Zoning Staff Report

Case Number: ZC-22-106

Zoning Map Amendment

Site Plan Comments

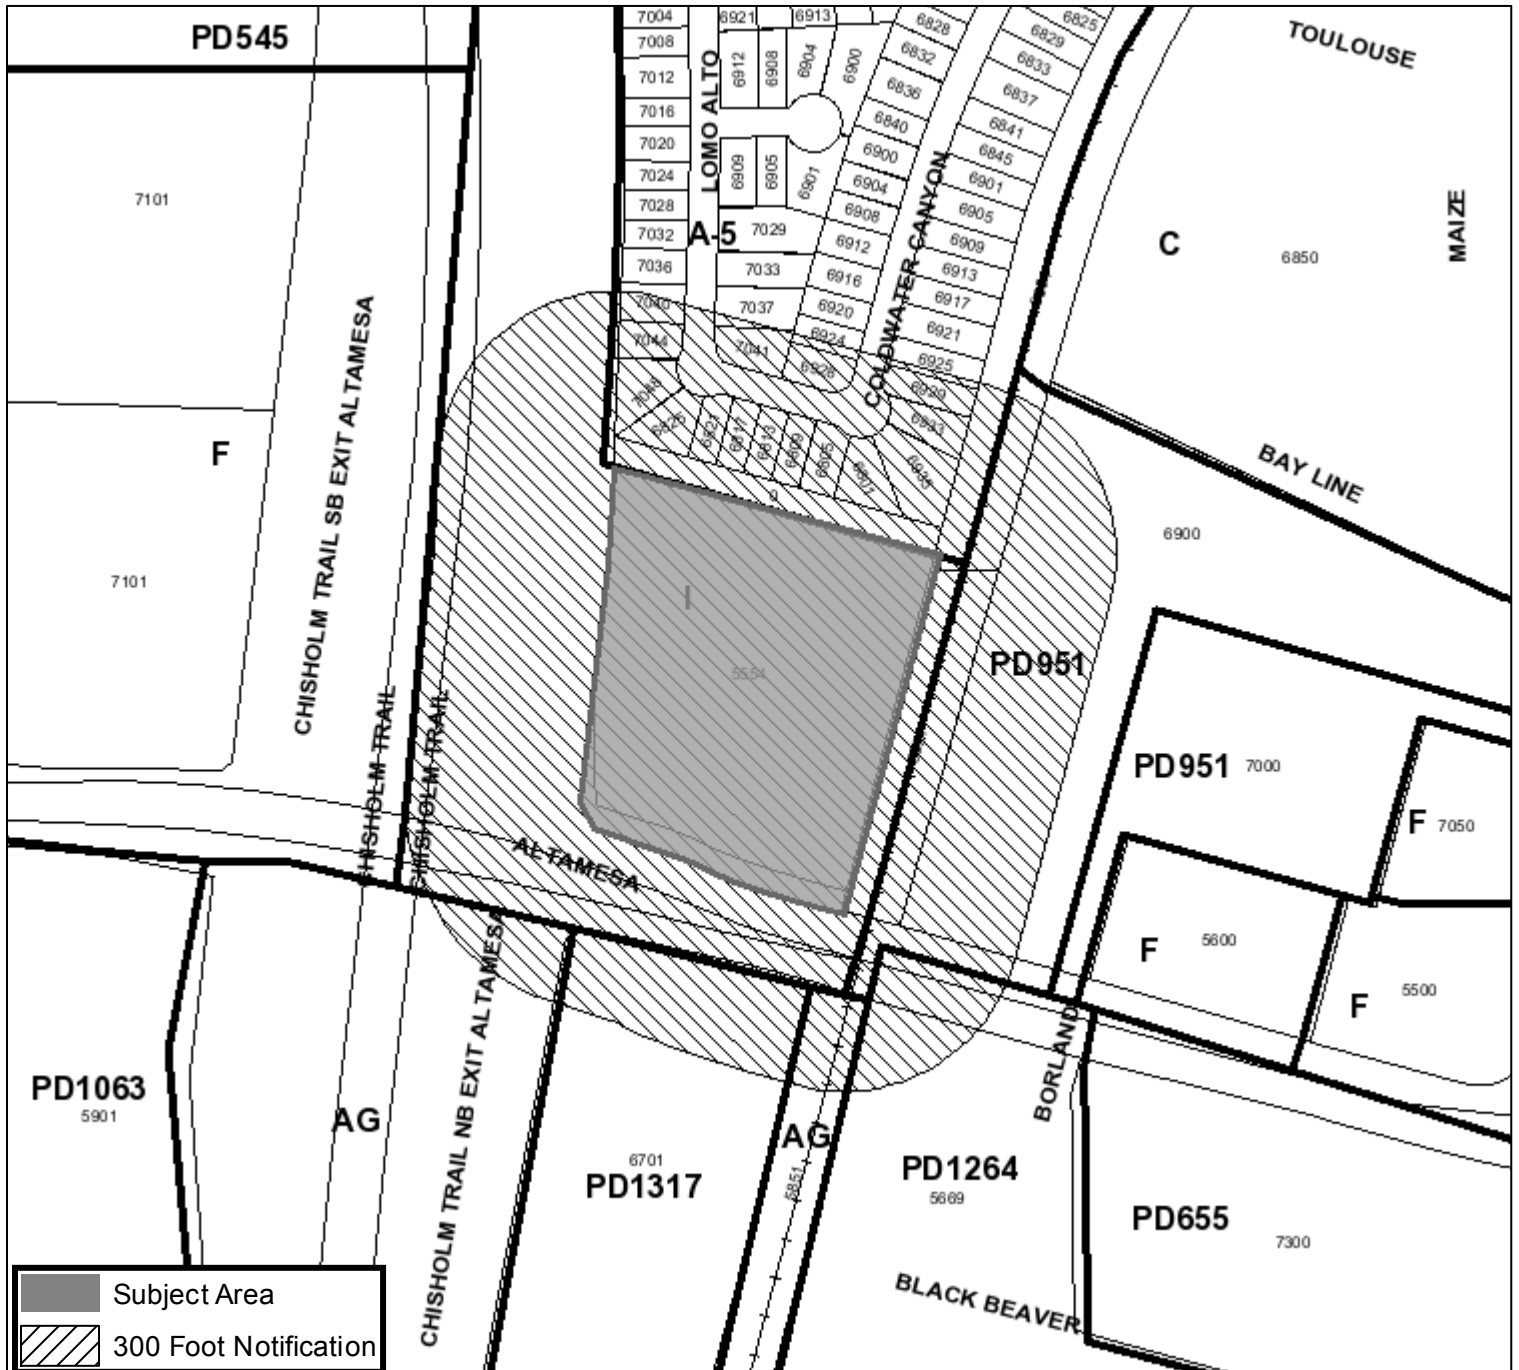
- Provide fencing type
- No parking or driveways shall be provided between a building and a public or private street. Parking shall be provided per § [6.201](#). Frontage on a controlled access highway shall not be considered a street for purposes of this section. (Waiver Requested)
- Open Space (Waiver Requested)
- Units per acre (Waiver Requested)

- Vehicle gates required to be a minimum of 20' wide when fully opened and equipped with Knox Locks. Access Control Permits required for electric gates.
IFC 2021/CFW Adopted Amendments Ordinance #25388-03-2022 Section 503.6 Access

- Fire lanes are required to be a minimum of 26' and provide hose lay within 150' to all exterior walls, measured in a 5' wide unobstructed path. That distance MAY be increased to 300' if the buildings are equipped with fire sprinkler systems.
IFC 2021/CFW Adopted Amendments Ordinance #25388-03-2022 Section 503.1.1 Buildings and Facilities

- Additional hydrants will be required to meet the following:
 - ? 600 ft. (300 ft. radius) of space between hydrants along a direct horizontal line.
 - ? 500 ft. hose lay distance to all points of building.

- FDC's for sprinkler and standpipe systems shall be located within 50 ft. of a dedicated street or fire apparatus access road and shall be within 150 ft. hose lay distance of the nearest fire hydrant. Each building shall be equipped with its own FDC, unless otherwise approved by the fire code official.
IFC 2021/CFW Adopted Amendments Ordinance #25388-03-2022 Section 507 Hydrants

- Named and platted Emergency Access Easements may be required for addressing.
